# Modification to Approved Project City of Rochester, New Hampshire

Case # 217-17-R16	Property Address 15 A Norway Plains
Type of project: Site Plan_x_;	Subdivision; Line Adjustment; Other
Project name Town Houses at Norway Plan	ins
Date of original Planning Board appr	roval November 14, 2016
Description of modification: Convert	rom 3 Story Units to Single level living, same bedrooms.
Convert from garages under units to parking in t	front of units
Name of applicant or agent filling out	this form Rob Graham
Mailing Address 81 Lakeview drive	
Phone Number: 603-479-3666	Email Address: Rob@Graham-consult.com
Please check box: Applicant Agent	
Signature of person completing form:	Date: 9/15/20
Signature of property owner (if differe	(nt): Date: 9/15/20
notices are required. (In contrast, proje abutters, are considered amendments fo	d by the Planning Board but no public hearing is held and no acts, which are considered to have a potential impact upon or which notice and a public hearing is required.) There is a simple matters ("administrative modifications") approved by

# PROPOSED MULTI-FAMILY DEVELOPMENT

# 15 NORWAY PLAINS ROAD ROCHESTER, NEW HAMPSHIRE (TAX MAP 215 LOT 17 AND LOT 17-

SITE PLAN

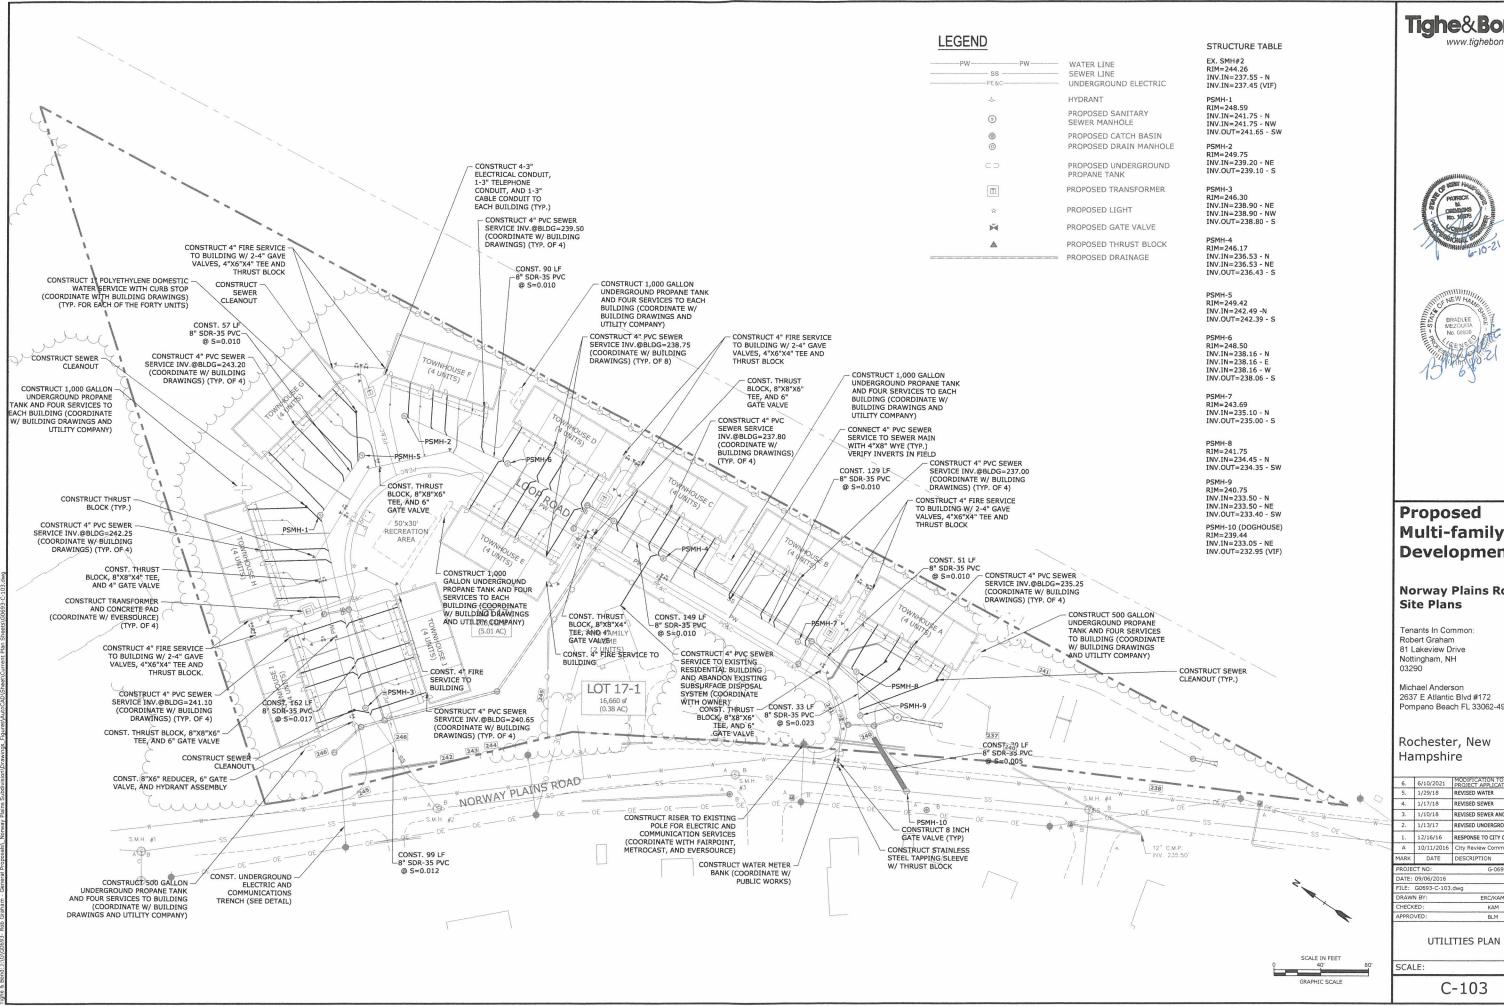
3.	6/10/2021	MODIFICATION TO APPROVED PROJECT APPLICATION
2.	3/23/2018	REVISED FOOTPRINTS
1.	12/16/2016	RESPONSE TO CITY COMMENTS
Α	10/11/2016	City Review Comments
MARK	DATE	DESCRIPTION
PROJE	CT NO:	G-0693
DATE:	09/06/2016	
FILE:	G0693-C-101	.dwg
DRAM	N BV:	EDC/VAM
